# SEATTLE ARENA

1700 FIRST AVENUE SOUTH

DOWNTOWN DESIGN REVIEW BOARD | RECOMMENDATION #3 | 2015 SEPT 1ST

OUTDOOR BALCONY

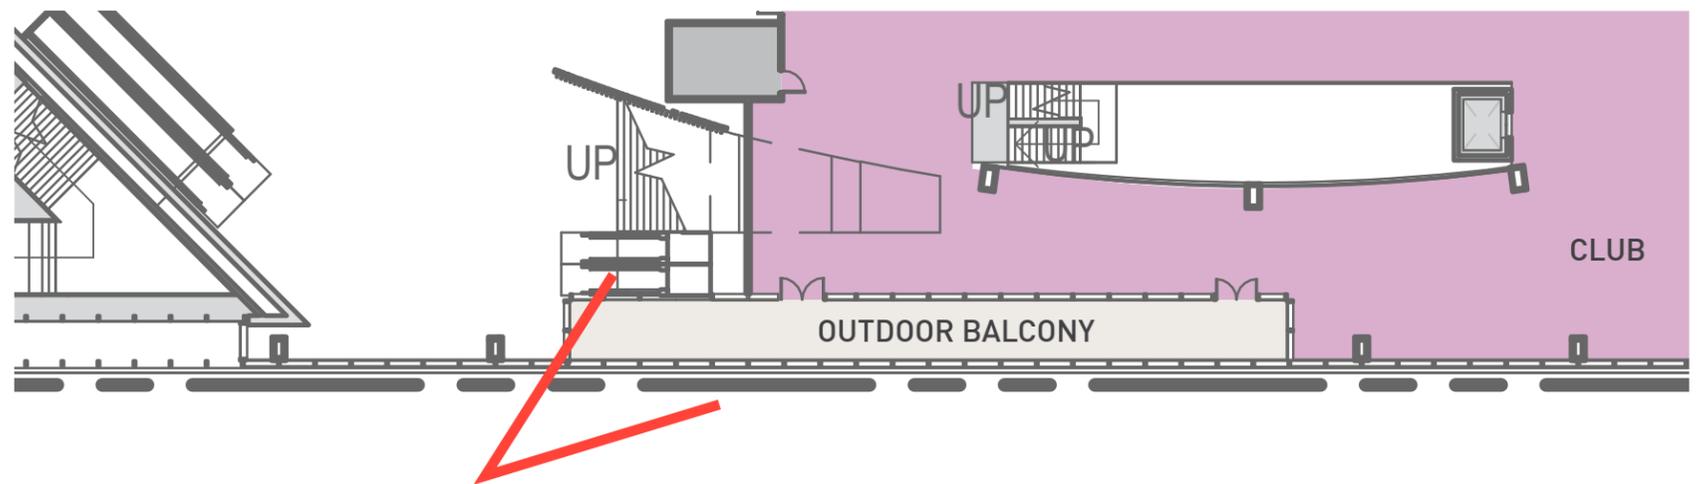
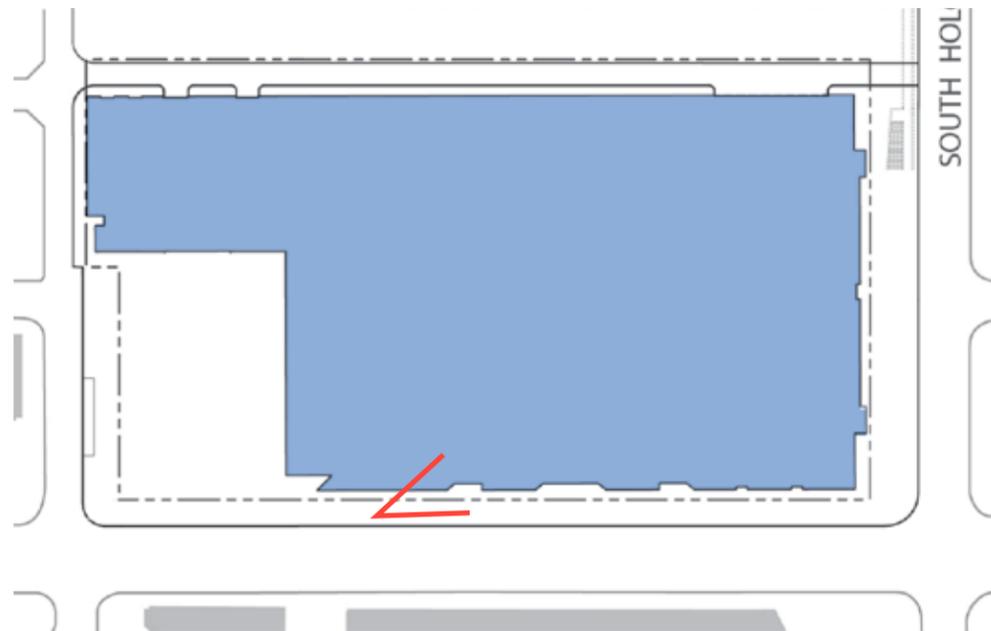
5. The Board agreed the balance of active/inactive ground level building uses was acceptable but requested more details on various specifics: the location and number of public entry doors into the restaurant/club; detailed views of each planter, canopy and/or doors at the indents along First Avenue; glass or spandrel treatments at 'performer/water service' (pg 77); doors and glass treatment at the triangular exit stairs. (C-1, C-3)

Comment noted. (see graphic this page)

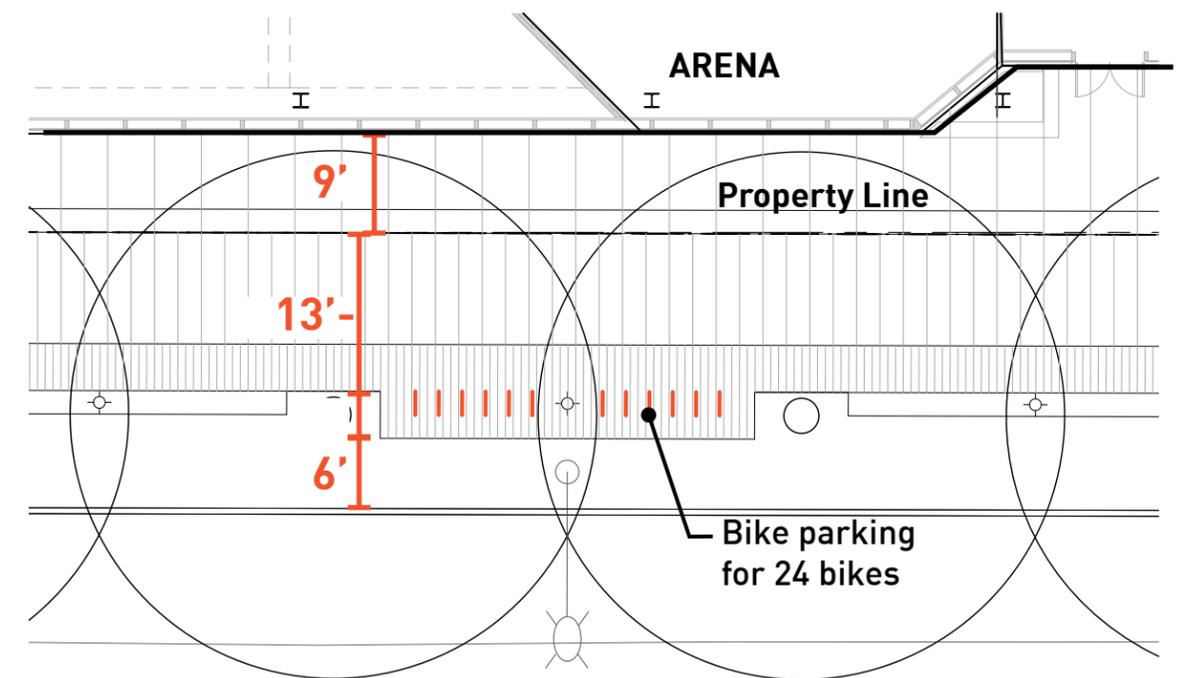
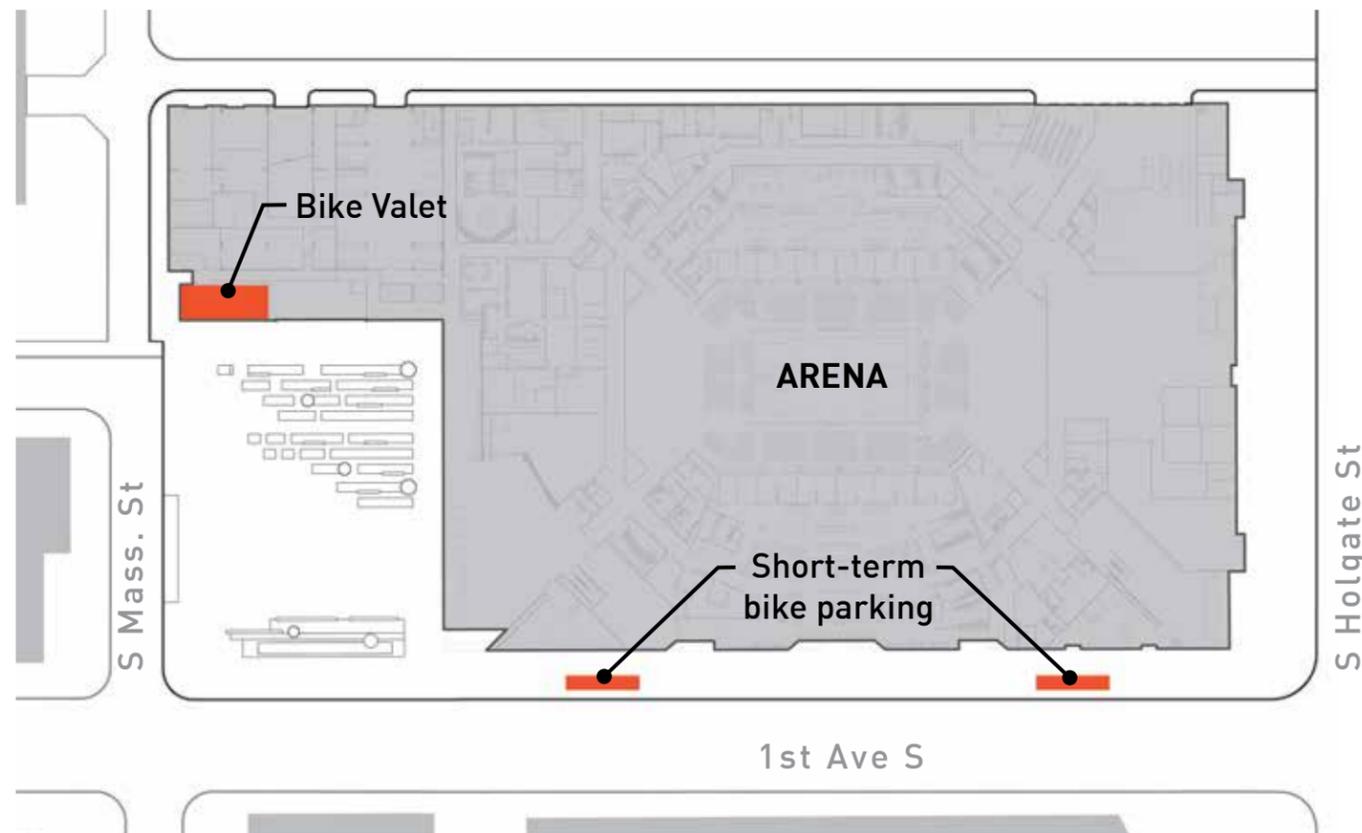
6. The Board agreed the First Avenue pedestrian clear walking width of about 16 ft should not be encumbered, and bike racks or other obstacles should be integrated into the curb-side planting zone. (B-3, D-6)

Comment noted. Site plan accommodates for 16' clear walking path.

Bike parking located across from setback areas without outdoor seating to maximize sidewalk clear width

VIEW FROM DOWNTOWN - ELEVATION 900FT

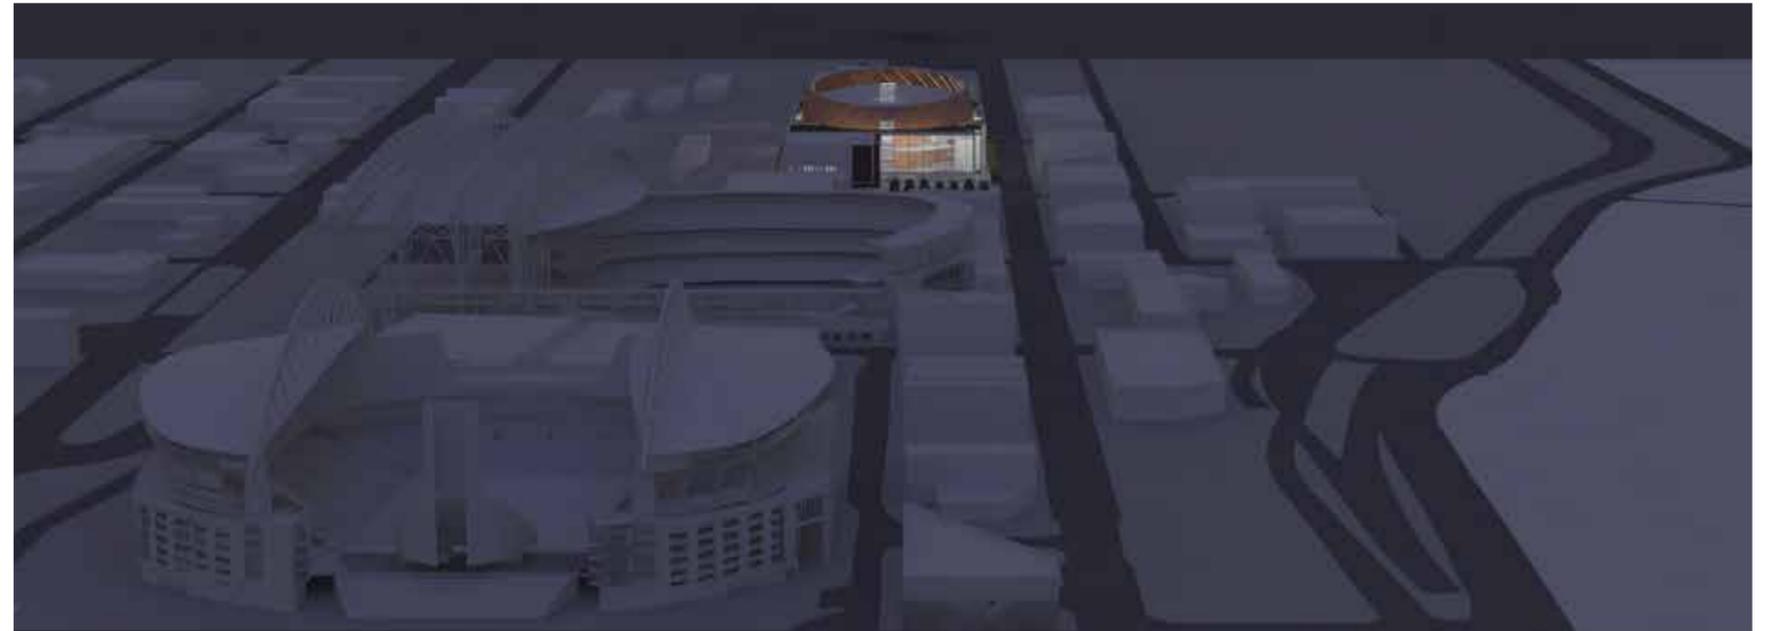
3. Material, color details and lighting information for the oblong inner roof of the turbine (including 'blimp signage' concepts), which will be visible from downtown towers, especially if night illuminated during the winter sport seasons (pg 72, 96). (A2,D-5)

Comment noted. Updated renderings provided.

CURRENT SCHEME

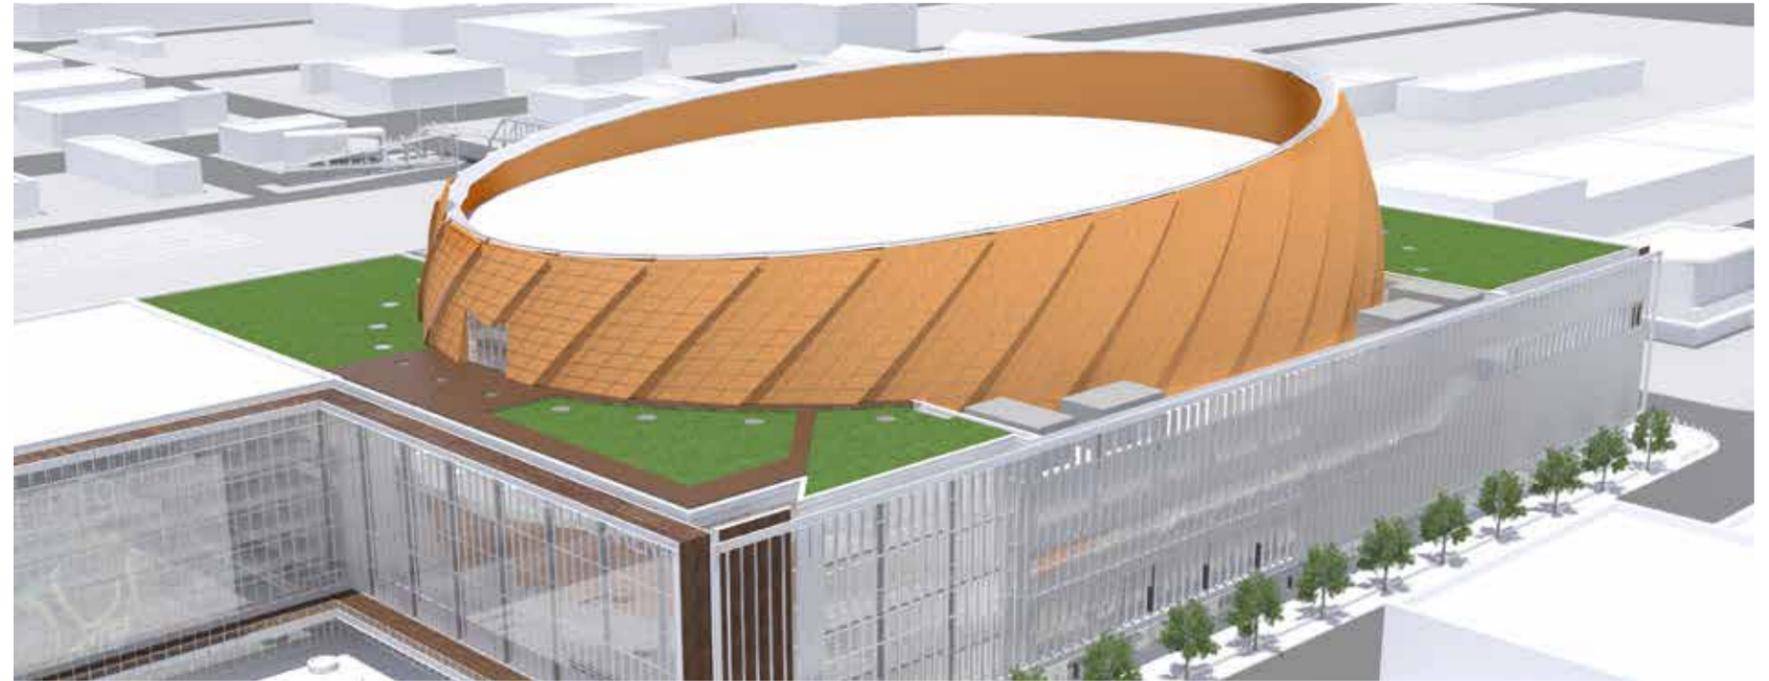
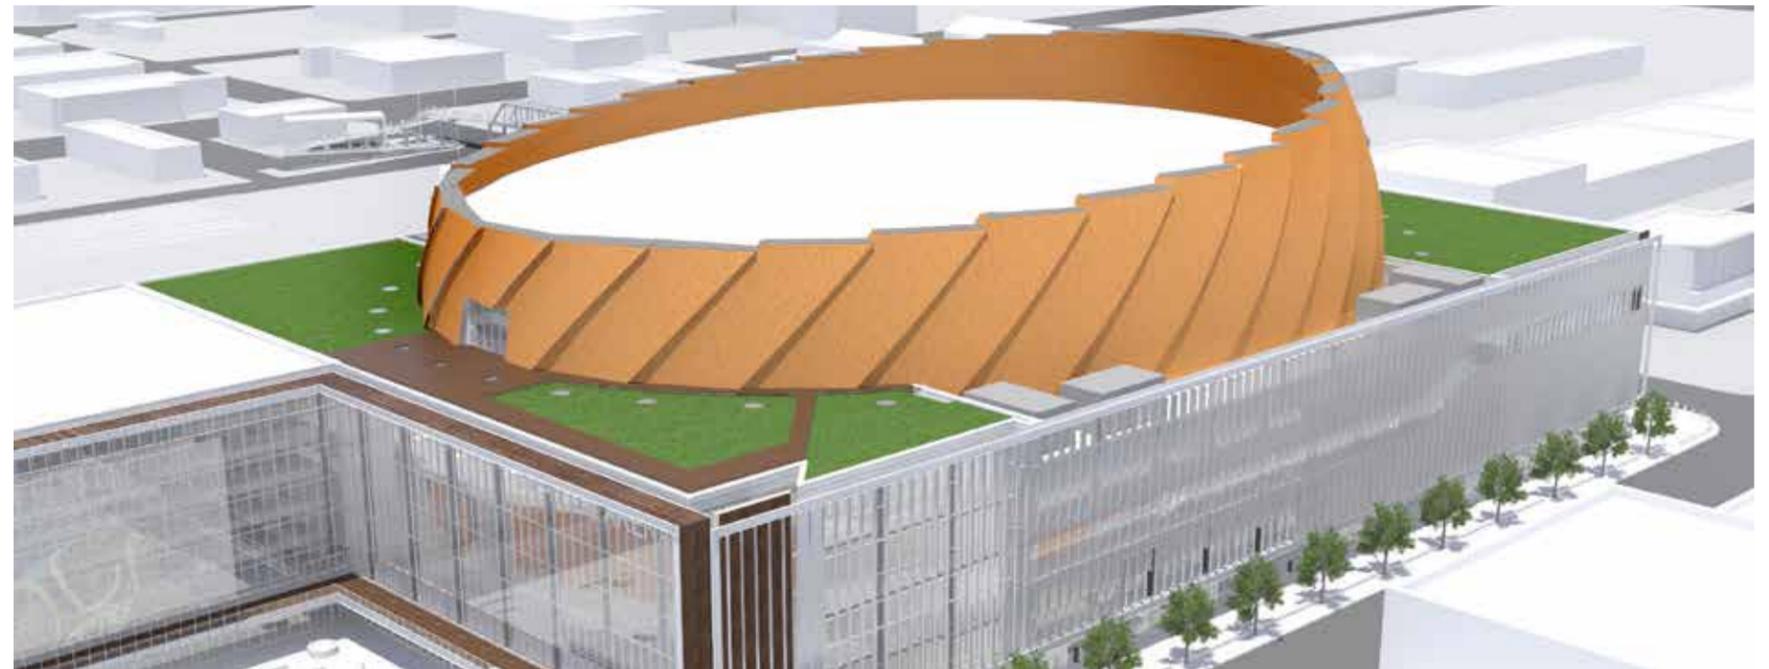
4. Graphics demonstrating how the blade joints are designed to be highly legible throughout the building, emphasized by lighting at night, and some other device in daylight; study flaring the blade tops and/or a more serrated top edge, less uniform/cut-off than shown on pg 80, 99. The Board noted that the proposed 18" offsets between blades is minimally acceptable. (A-2, C-2)

Comment noted. (see graphic this page)

PLAN DETAIL AT BLADE COVE

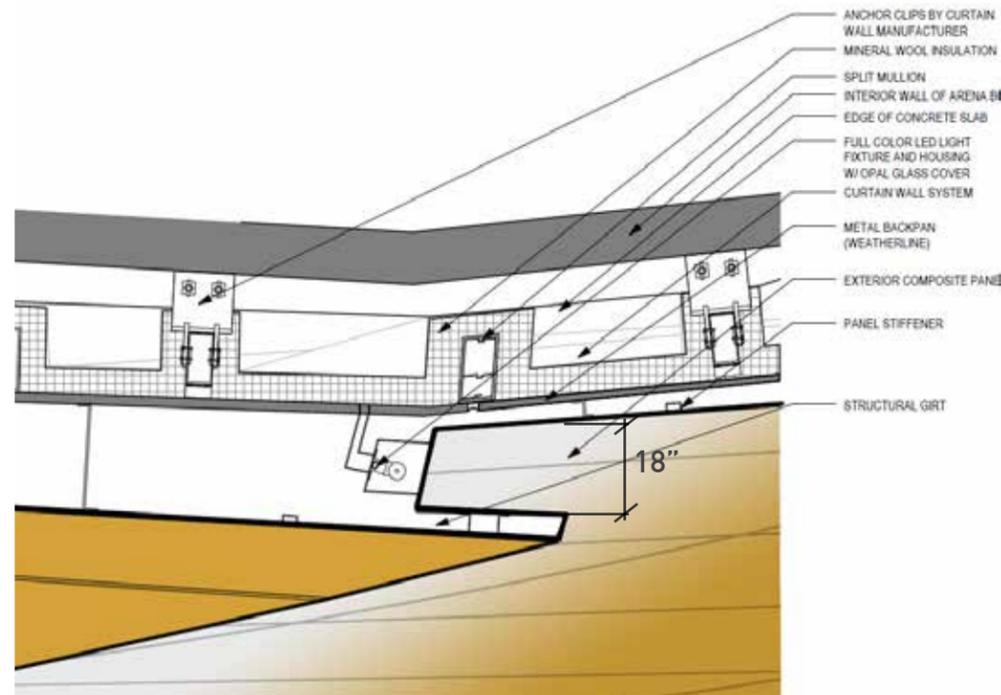
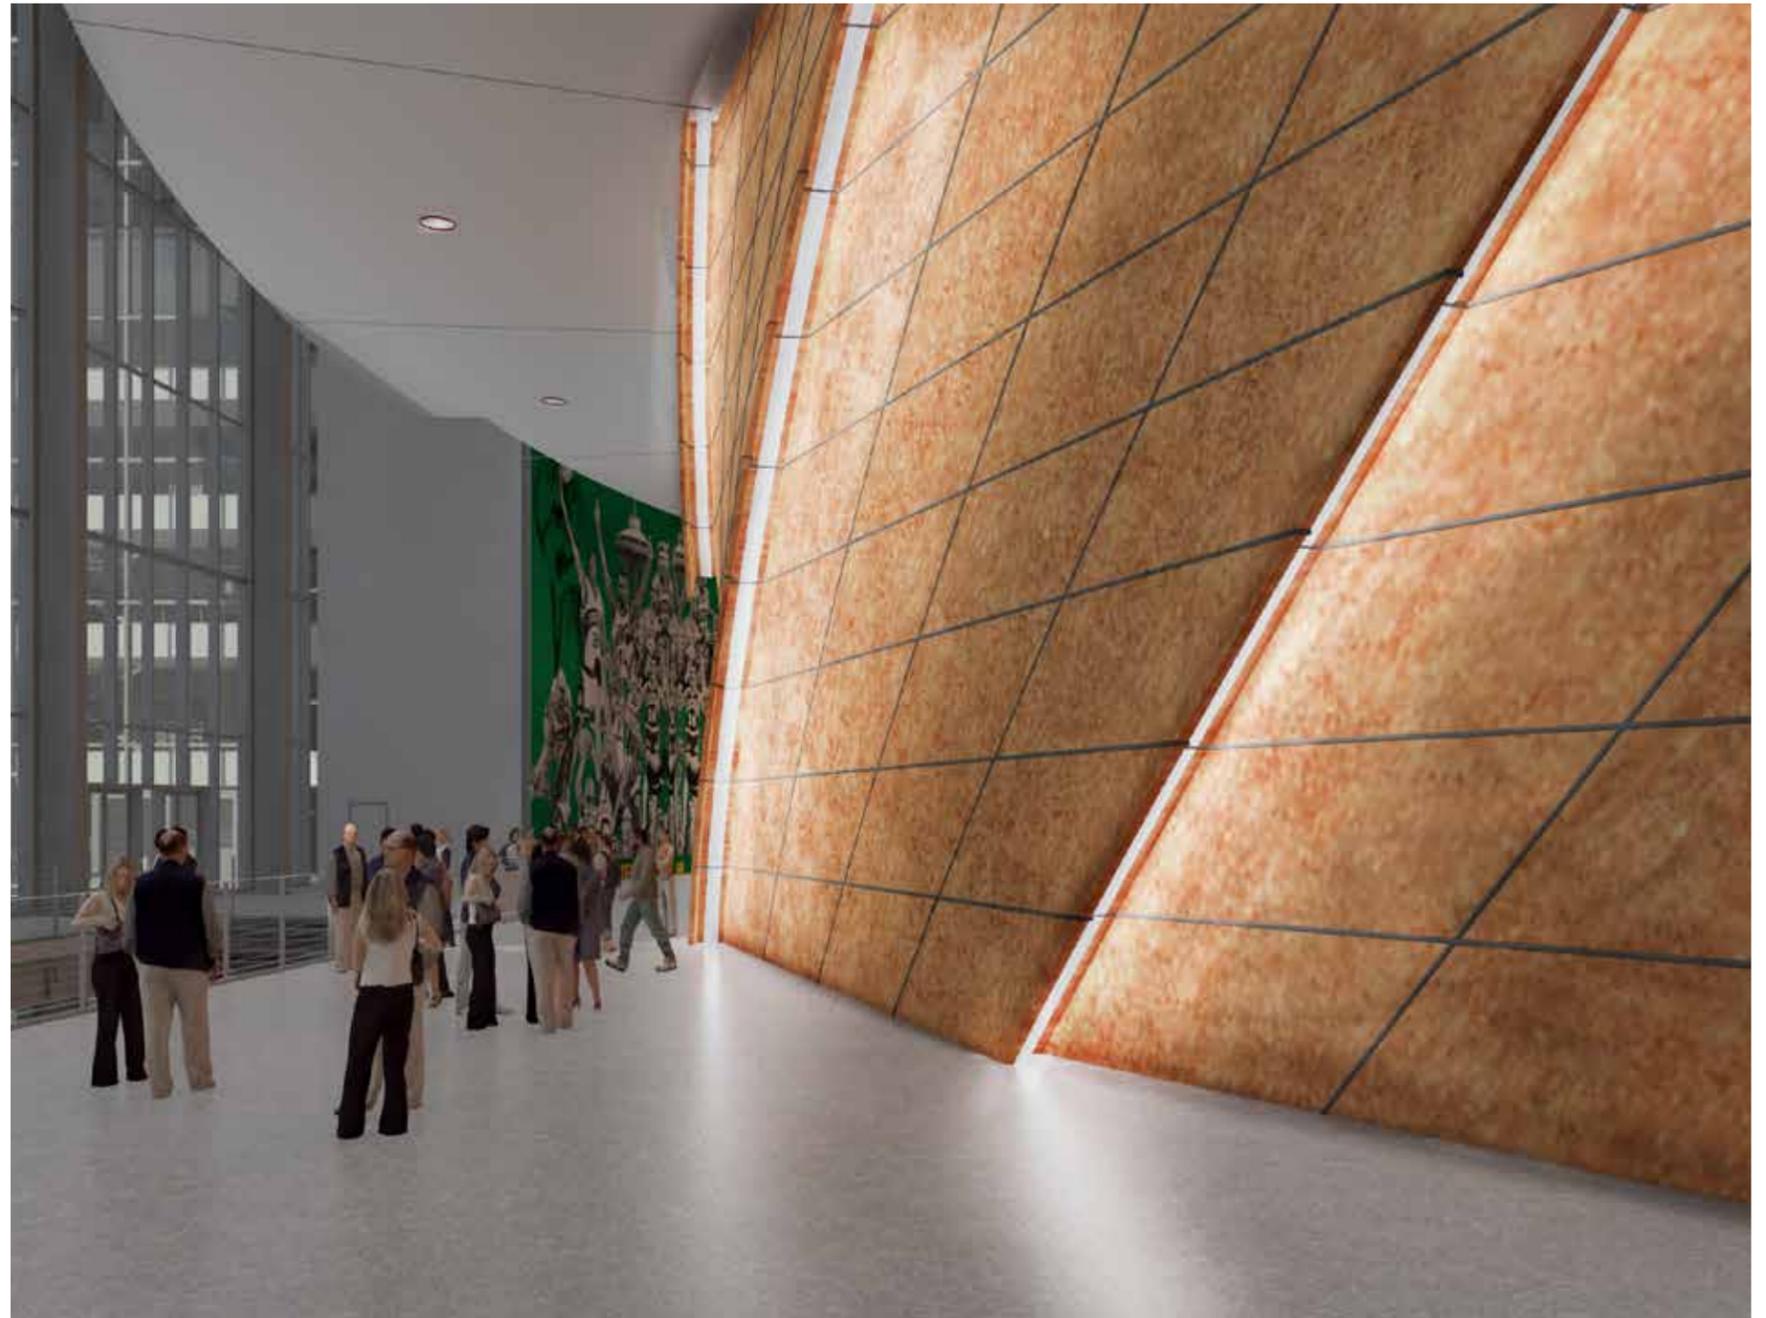
4. Graphics demonstrating how the blade joints are designed to be highly legible throughout the building, emphasized by lighting at night, and some other device in daylight; study flaring the blade tops and/or a more serrated top edge, less uniform/cut-off than shown on pg 80, 99. The Board noted that the proposed 18" offsets between blades is minimally acceptable. (A-2, C-2)

Comment noted. (see graphic this page)
